Sheet: /TPS631000 Power Regulation/
File: TPS631000_PowerRegulation_v2.kicad_sch

Rev:
Id: 2/5

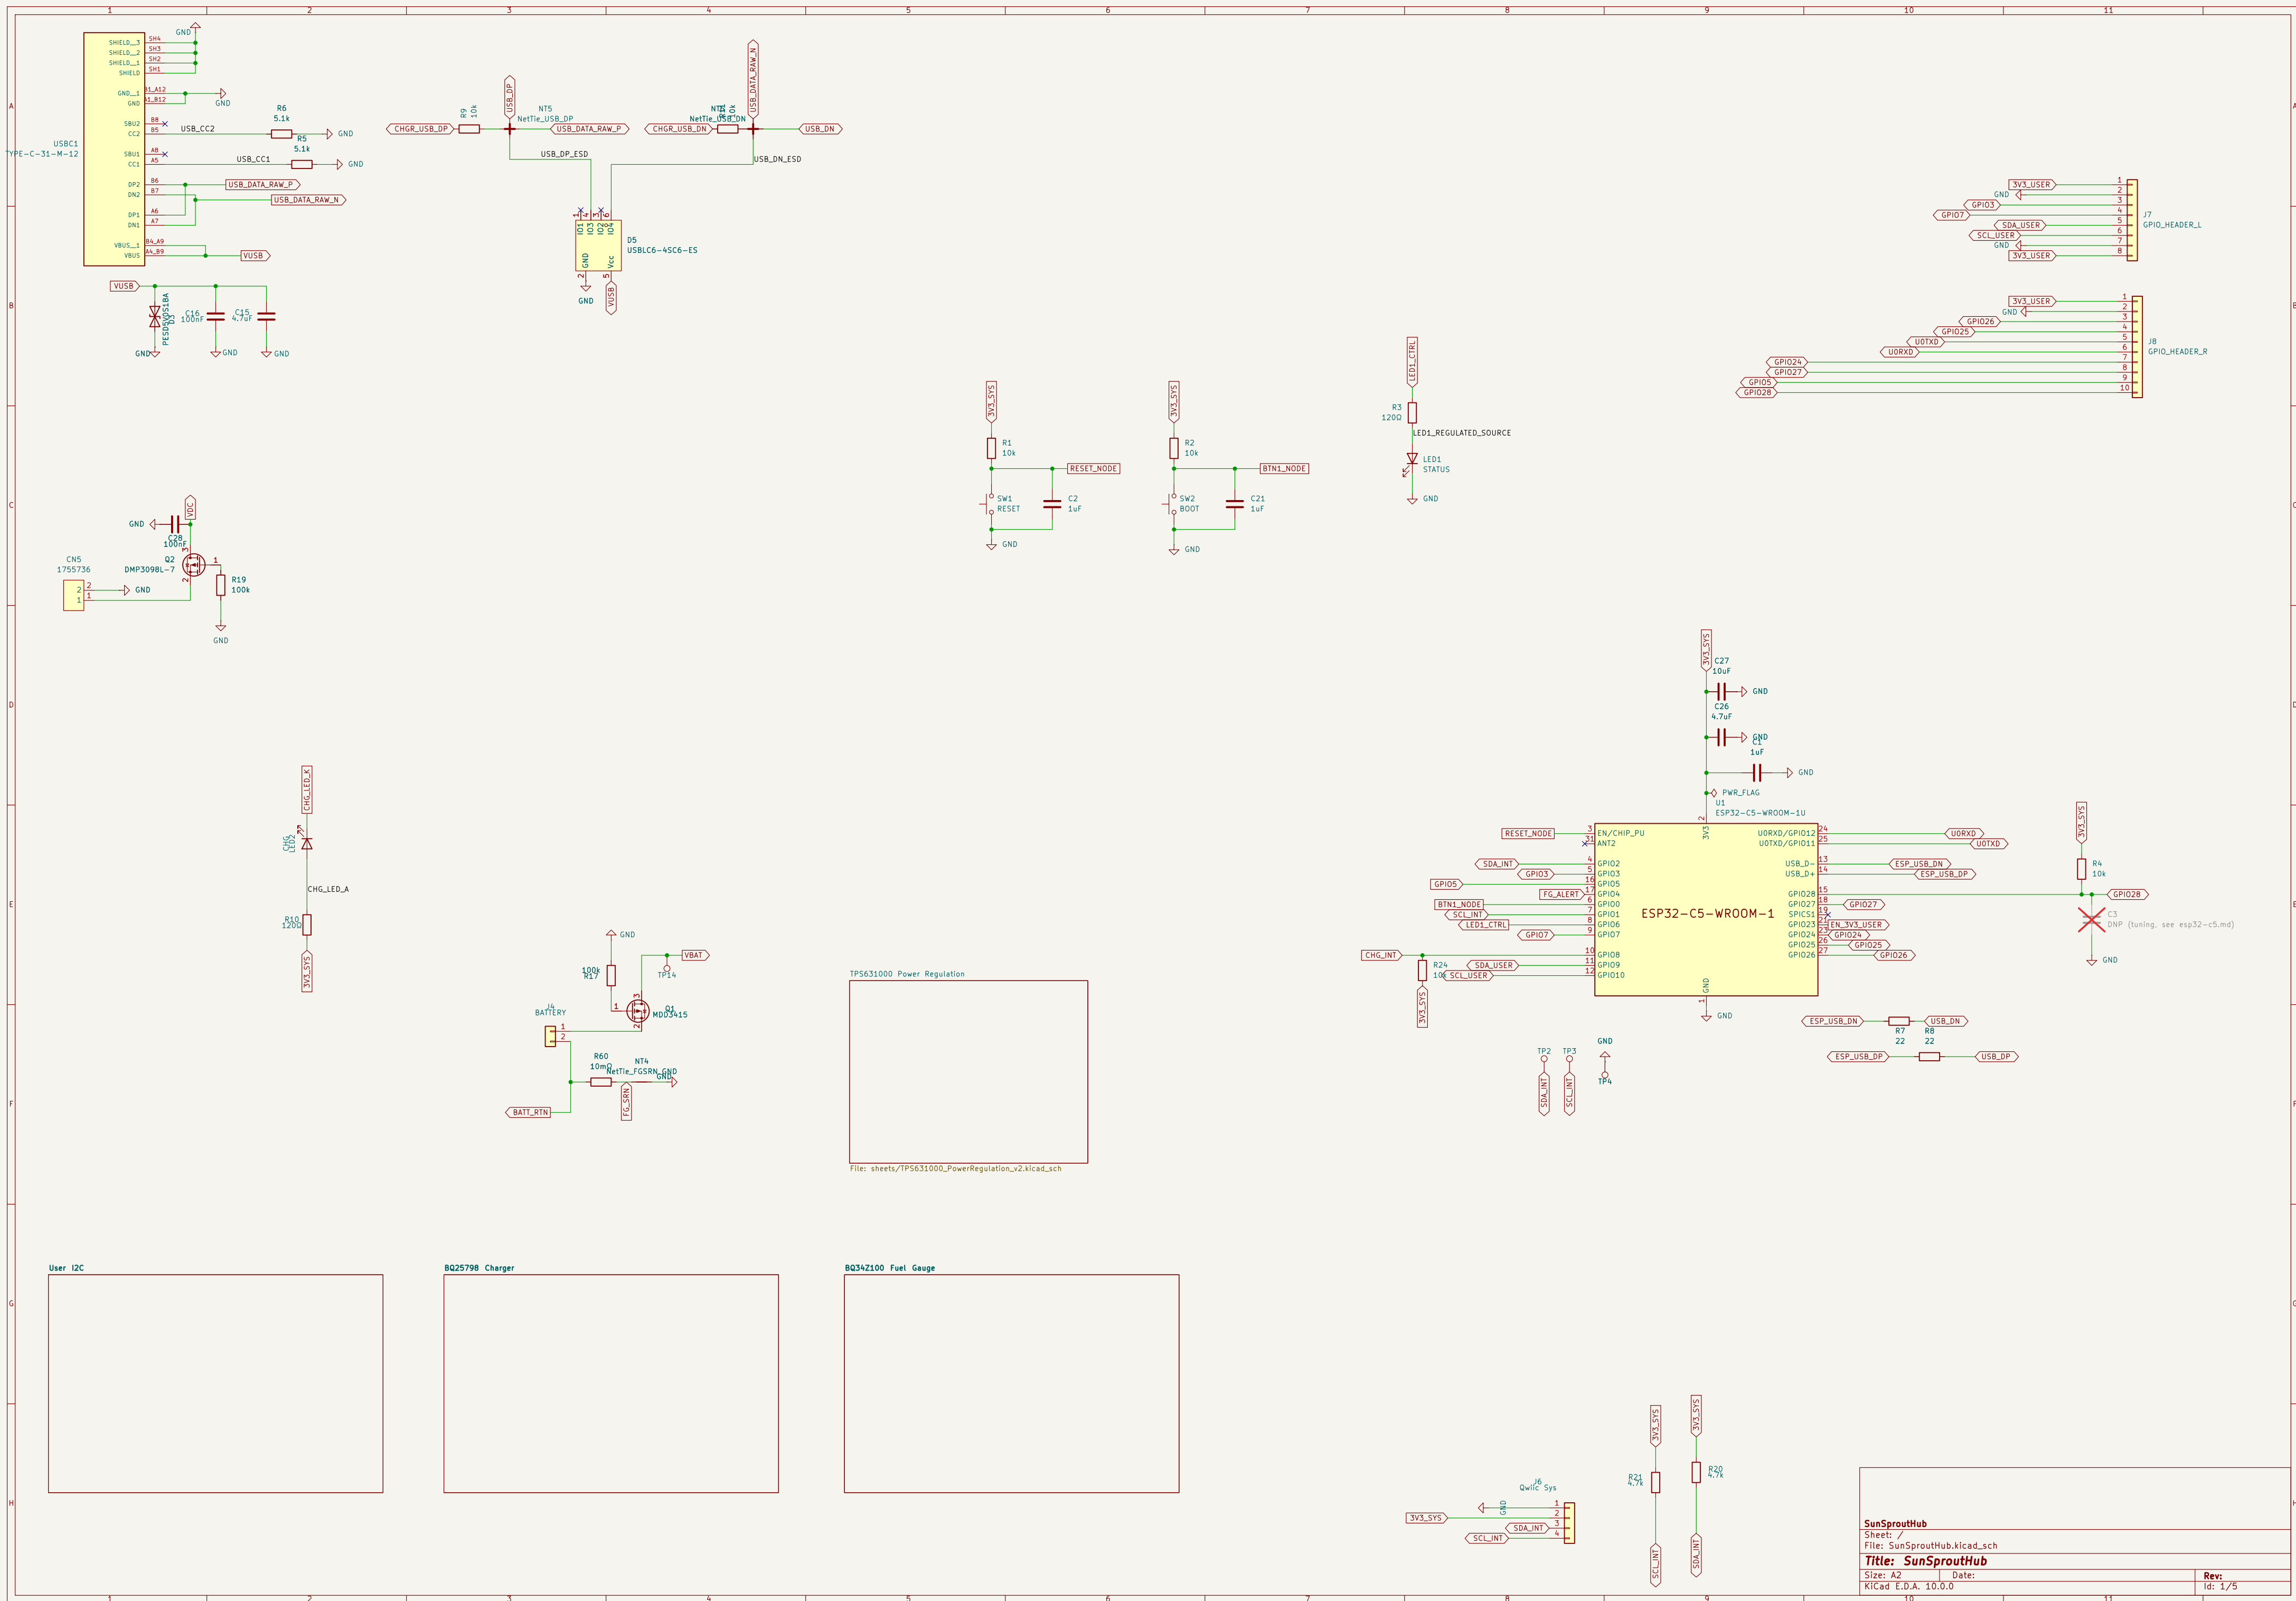
Replaces BQ27427YZFR, BQ27427/BQ27426 have zero LiFePO4 chemistry-profile support (confirmed against datasheet -- only 4.2/4.35/4.4V Li-Ion profiles exist), BQ34Z100 explicitly supports LI-Ion and LiFePO4. Architecture changed from BQ27427's high-side integrated 7mOhm shunt to a low-side external sense resistor (R60 on the main sheet, in series between the true battery- terminal and system GND) -- SRP/SRN Kelvin-sense across R60.
